Work Order ID 159232

Item Name: Lug

DRAWING NO. D3394	TITLE LUG	REV. B	DART AEROSPACE LTD ENGINEERING ORDER		D.E.O. NO. D3394-B-1	SHEET NO. SHEET 1 OF 1	SCALE NTS
DRAWN AJS	CHECKED	MFG. APPR.	APPROVED		DE APPR.		
DATE 09.11.04	DATE 09.11.04	DATE 09.11.04	DATE 09/11/04		DATE 09/11/04

DRAWING NO. D3394	TITLE LUG	REV. B	DART AEROSPACE USA, INC ENGINEERING ORDER		D.E.O. NO. D3394-B-2	SHEET NO. SHEET 1 OF 1	SCALE NTS
DRAWN <i>GP</i>	CHECKED <i>SC</i>	MFG. APPR. <i>M</i>	APPROVED <i>MP</i>		DE APPR. <i>MP</i>		
DATE 11.05.02	DATE 11.05.09	DATE 11.05.08	DATE 11.05.08		DATE 11.05.09

SECTION A-A

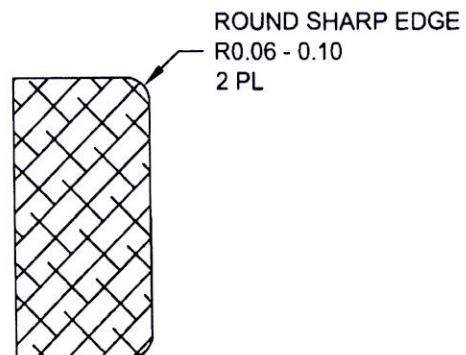
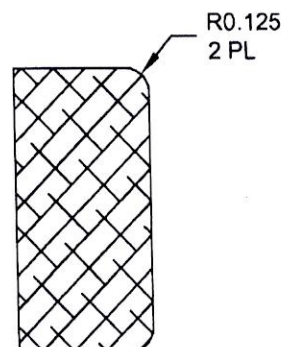
SHEET 4 ZONE A,1 MODIFY SECTION A-A AS SHOWN:

REASON: DRAFTING ERROR

IS:

D3394-1RG LUG (SHOWN)
D3394-3RG/-5RG LUGS (SIMILAR)
D3394-041RG/-043RG/-045RG LUG ASSEMBLIES (SIMILAR)

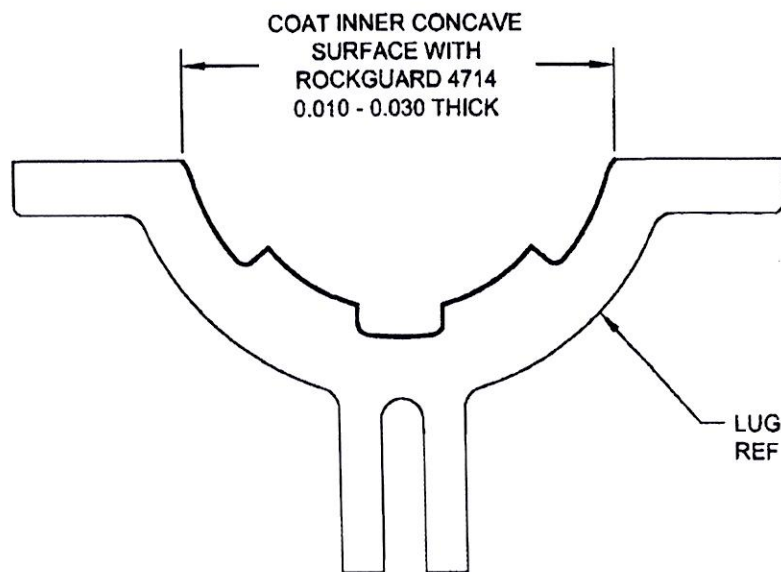
PURPOSE

ADD D3394-xRG OPTION

D3394-xRG MOUNTING LUGS ARE IDENTICAL TO D3394-x MOUNTING LUGS, HOWEVER AFTER FINISH, COAT INNER CONCAVE SURFACE WITH "PLUS ONE ROCKGUARD 4714" AS SHOWN BELOW.
